Determination 2017/068

Regarding an amendment to a building consent for an apartment building with tiled decks at 7 Salisbury Avenue, Mount Maunganui, Tauranga

This determination considers the authority's refusal to grant an amendment to a building consent for remediation of tiled decks above habitable spaces. The matter turns on whether the acoustic mat that forms part of the proposed tiling system will comply with Clauses G6 and B2.

Figure 2: Deck construction over habitable spaces

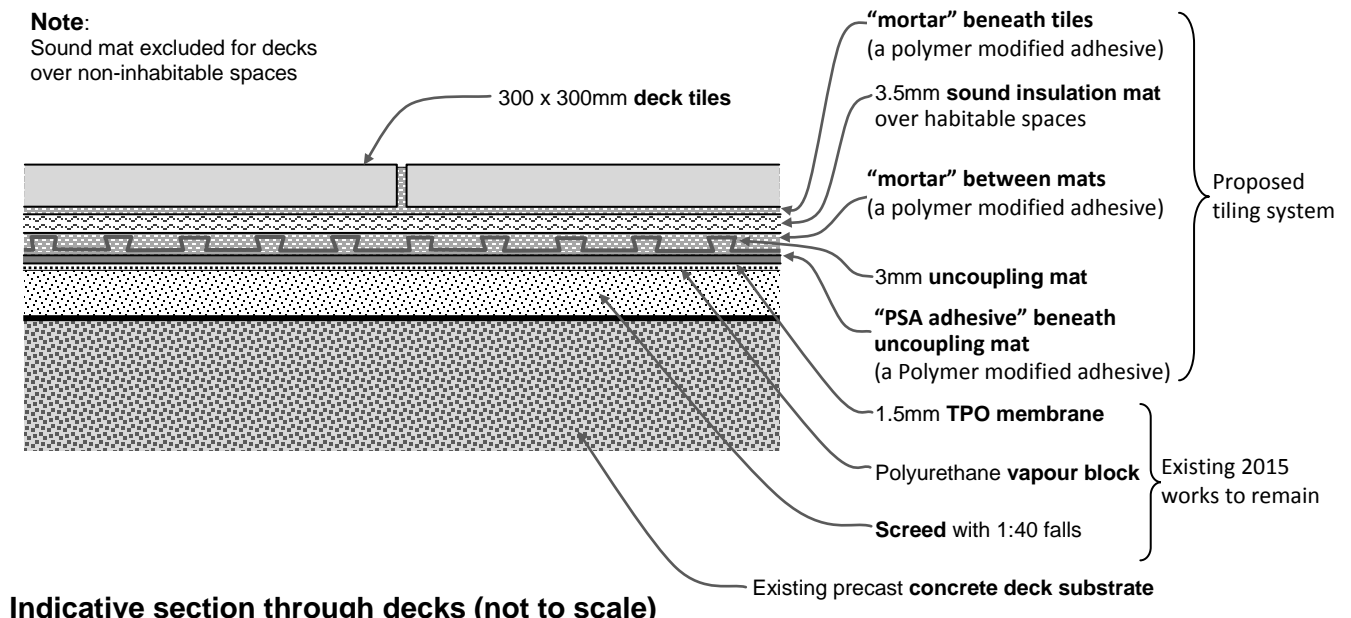
3.7.3 The authority carried out a review of the proposal and an in-house report dated 25 August 2016 records comments and opinions on the documentation provided. The review included the following comments:

- Most authorities will not accept tiling on membranes because the mortar and the membrane are not compatible. The uncoupling mat is designed to be a slip layer to reduce the risk of incompatibility.
- There were “currently ... problems with” another uncoupling mat which has a BRANZ appraisal, and that company is using tile pedestals in place of a mat. (I note here that the uncoupling mat in that instance was a 0.4mm thick butyl rubber sheet for use on floors: it is not comparable with the uncoupling mat proposed.)
- In-service history shows “failures of the system” due to water entering under the tiles.

3.7.4 In a letter to the project manager dated 9 September 2016, the authority noted that it had reviewed and assessed the proposed amendment and had decided that the documentation provided:

...does not contain sufficient evidence to show all the identified performance criteria of all relevant clauses will be met especially B2 durability, and to a lesser degree B1 structure and for the large [decks] E2 external moisture.

- the entire system, including all the building materials, components, and the proposed construction method would satisfy the functional and performance requirements for the periods required by the Building Code
- damage to any elements in the proposed tiling system could be easily detected and repaired without damaging the integrity of the system, allowing elements of lesser durability to be replaced without removing others of greater durability
- the tiles of the ‘large [deck] areas using the ... sound mat’ will stay in place, with a ‘low probability of not causing loss of amenity’.

- queried how the acoustic and uncoupling mats effected the performance requirements of the TPO membrane and how the membrane will be maintained
- stated that the alternative solution proposal was "assessed as near as practical against the Acceptable Solution" and in the authority's view the evidence provided does not establish compliance with the Building Code
- noted there has been no assessment in the preliminary draft of the decks in regard to Clause G6 Airborne and impact sound
- provided photographs of the tiles in situ, showing the tile "grout was not waterproof"

- 4.4.3 On 24 July 2017 the authority responded to the draft determination, advising that it had no concerns regarding ongoing maintenance or performance of the TPO membrane, but only with regard to compliance with Clause B2, and seeking clarification of the durability periods that applied to the tiling system. The authority noted its concern regarding durability of the tiling system was because of the scale of the decks and costs that would be involved in any replacement, and that the manufacturer has advised the acoustic mat is not suitable for external applications and the uncoupling mat should not be installed beneath the acoustic mat and is not recommended for over membranes.

- 6.2.1 The project manager has provided results of acoustic tests of the subject decks and for tests carried out in a building located in Auckland using the same or similar materials.
- 6.2.2 I am of the view that the acoustic performance of the acoustic mat is unlikely to be significantly affected by moisture as it would continue to act as a non-rigid interlayer that does not transmit impact noise to the extent a rigid path would. I note the use of the uncoupling mat of itself may also assist in lessening impact noise from the deck

areas into habitable spaces below. I consider there are reasonable grounds to be satisfied that the tiling system as proposed complies with Clause G6.

- 6.3.2 In regards to the acoustic mat, I am of the view that failure of the tiling system with respect to Clause G6 would be easily detected during normal use of the building by those in the habitable spaces below. While some components of the tiling system, such as the tiles, may be easily accessed and replaced and have a required minimum durability period of 5 years, I am of the view that other components of the tiling system would be moderately difficult to access and replace. I consider the durability period for the acoustic mat is 15 years.

- 6.3.3 In regards to the use of the acoustic mat externally, I note that the acoustic mat is constructed of the same material as the uncoupling mat, which can be used externally; both the uncoupling and acoustic mats are water-resistant and should not be affected by the effects of water ingress in terms of being degraded by the presence of moisture. I am of the view that there are reasonable grounds to be satisfied that the tiling system will comply with Clause B2 insofar as it applies to Clause G6.

- 7.1 In accordance with section 188 of the Building Act 2004, I hereby determine that the proposed deck tiling system complies with Clauses G6 Airborne and impact sound and Clause B2 Durability insofar as it applies to Clause G6 and accordingly I reverse the authority’s decision to refuse to grant the amended building consent in this respect.
